Memorandum

Maddox Resubdivision

Final Plat Resubdivision

Case Number: 23.01 FSP

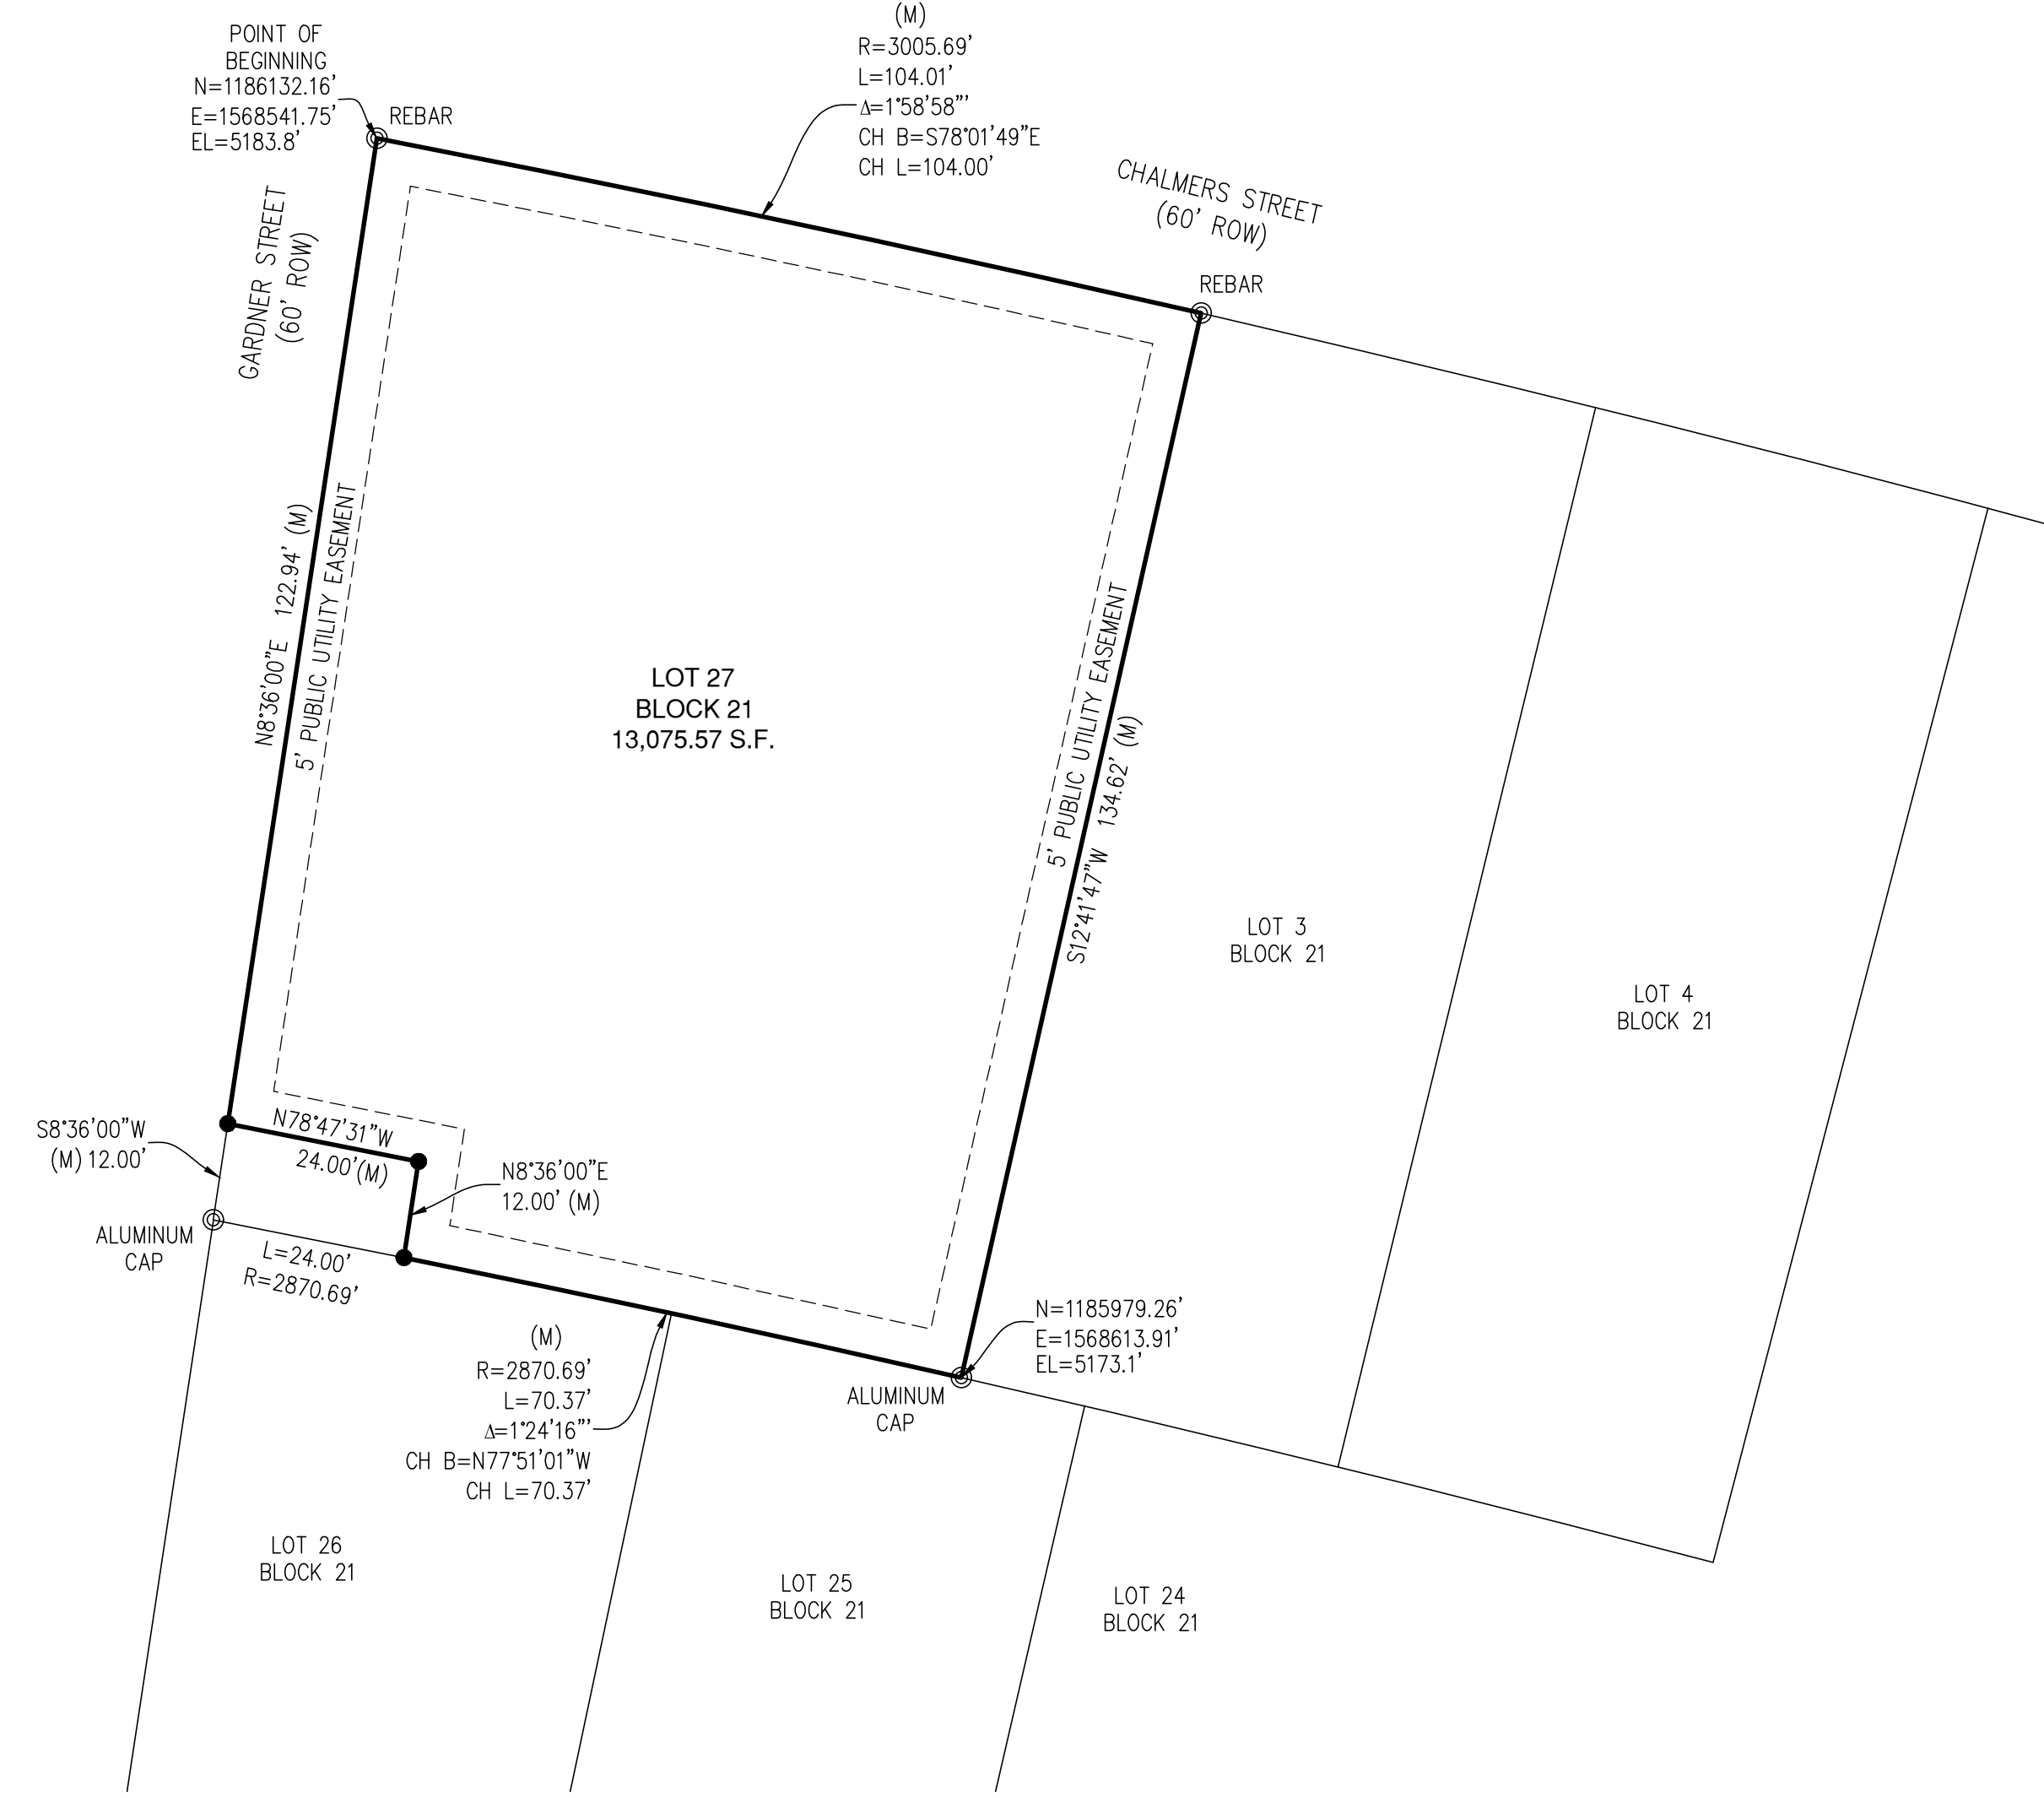
1. Revise the plat title, all legal descriptions, and the dedication to except out that 12' x 24' portion in the SW corner of Lot 1. It should read:
 - a. "Vacation & Replat of a portion of Lot 1 & all of Lot 2, Block 21, Mountain View Suburb to be known as Lot 1A, Block 21, Mountain View Suburb..."
2. Add at 5' general utility easement around the interior boundary of the subdivision.

3. Survey Reviews:
 - a. Add elevations with the given coordinates and a note with vertical datum
 - b. Verify the survey date of April 2022
